26 February 2016
Our Ref: 9057A.4KM

**RE: Submission in response to the Kellyville Station Precinct Proposal
Land at Hickson Avenue and Daffodil Crescent, Kellyville**

Figure 2: Proposed Revised Concept Plan for the Site (Robertson + Marks)

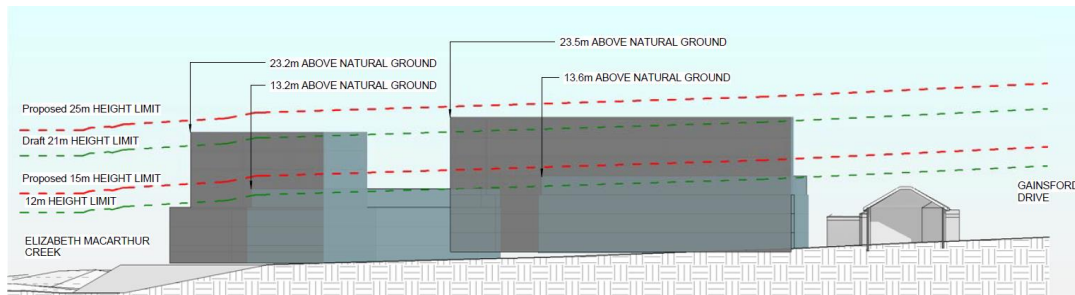
4. To demonstrate that slightly greater height limits can be accommodated on the Site without adverse visual or other built environment impacts, a Revised Concept Plan for the Site has been prepared by Robertson + Marks (R+M) Architects (see **Attachment 1**) and **Figures 2 and 3** are extracts of that Revised Concept Plan.

This Revised Concept Plan proposes a 25 metre height limit across the centre of the Site (from western boundary to eastern boundary) which would allow 7-storey buildings and roof structure and a 15 metre height limit along the northern and southern sides of the Site which would allow 4-storey buildings and roof structure.

It is noted that in all other respects, the Revised Concept Plan complies with the Draft DCP requirements (particularly setbacks) and applicable ADG provisions and provides for the public roads and creek crossing depicted in the Draft Plans.

Figure 4: Proposed amendment to the height limit on the central, eastern side of the Site.

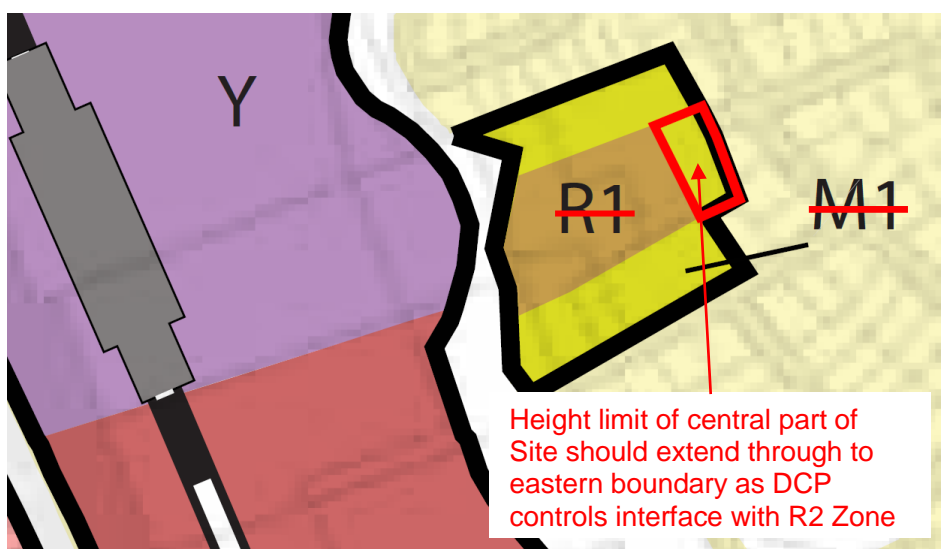
5. The Revised Concept Plan also demonstrates that an appropriate outcome is achieved from the proposed height limits and building forms with respect to overshadowing of external public domain, private land and internal solar access.
6. The proposed height map includes a 25-metre wide strip of 12m height limit along the eastern side of the Site which is not necessary. The Draft DCP contains controls relating to side setbacks and specifically (Draft Control 6.1.3(7)) requires that “Where an apartment building adjoins land in the R2 zone, the minimum side and rear boundary setback is increased by an additional 3m”. For this Site, an apartment building on the eastern, centre part of the Site with a height of between 5-8 storeys would be required to have a setback of 12 metres from the boundary of the eastern adjoining R2 Zone.

Accordingly, the proposed Height mapping artificially constrains future development on this part of the Site and should be amended as depicted in **Figure 4**.
